# Access Compliance Report

## Public Rights-of-Way

### (Curb Ramps)

Intersection ID: 47820	Main Street: HERONS_POND_CT	Cross Street: ROYAL_FERN_LN	Location: NE
ADA ID: A445609576F1	Ramp Type: PerpDiag	Initial Pass/Fail: Fail	Overall Compliance: No
Severity Score: 50			
Codes/Mitigation Info/Possible Solution		Field Measurements/Component Compliance

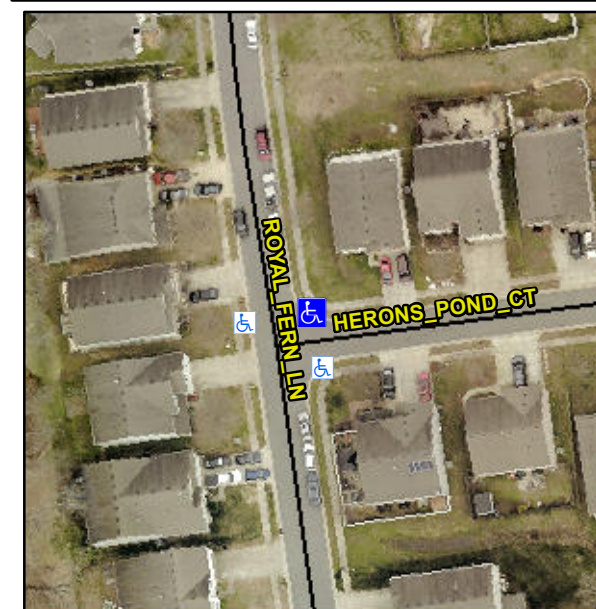
**Not Found, R304.2.2, R304.5.3**

Compliance	Description	Data	Compliance	Description	Data
N/A	Ramp Length (in)	49.5	No	Ramp Slope (%)	13.4
Yes	Ramp Width (in)	48.0	No	Ramp XSlope (%)	9.6
N/A	Flare Type LT	N/A	N/A	Flare Type RT	N/A
N/A	Flare Slope LT (%)	N/A	N/A	Flare Slope RT (%)	N/A
N/A	Flare Traversable LT?	N/A	N/A	Flare Traversable RT?	N/A
N/A	Landing Length (in)	N/A	N/A	DWS Provided?	N/A
N/A	Landing Width (in)	N/A	N/A	DWS Contrast?	N/A
N/A	Landing Slope (%)	N/A	N/A	DWS Length (in)	N/A
N/A	Landing X Slope (%)	N/A	N/A	DWS Full Width?	N/A
N/A	Landing Curb? (Y/N)	N/A	N/A	DWS Offset (in)	N/A
N/A	Shared Landing?	N/A			
N/A	Gutter Ponding?	N/A	N/A	Gutter Slope (%)	N/A
N/A	Gutter Lip Ht (in)	N/A	N/A	Gutter X Slope (%)	N/A
N/A	Painted X Walk1?	No	N/A	Painted X Walk2?	No
	X Walk 1 Direction	To W		X Walk 2 Direction	To S
N/A	X Walk 1 Width (in)	N/A	N/A	X Walk 2 Width (in)	N/A
	X Walk 1 Slope (%)	4.0		X Walk 2 Slope (%)	2.8
	X Walk 1 X Slope (%)	6.3		X Walk 2 X Slope (%)	5.7

N/A	Ramp inside XWalk1?	N/A	N/A	Ramp inside XWalk2?	N/A
	Road Slope (%)	8.9	N/A	Clear Space?	N/A
	Road X Slope (%)	1.3	N/A	Clear Space to XWalk (in)	N/A
N/A	Any Obstructions?	N/A	N/A	Storm Grate/Utility Hazard?	N/A
	Obstruction Type			Storm Grate/Utility Type	
		N/A			N/A
		Yes		Surface Condition? (G/P)	Good

**Remove & Replace Curb Ramp With Two New Directional Ramps or Equivalent.**
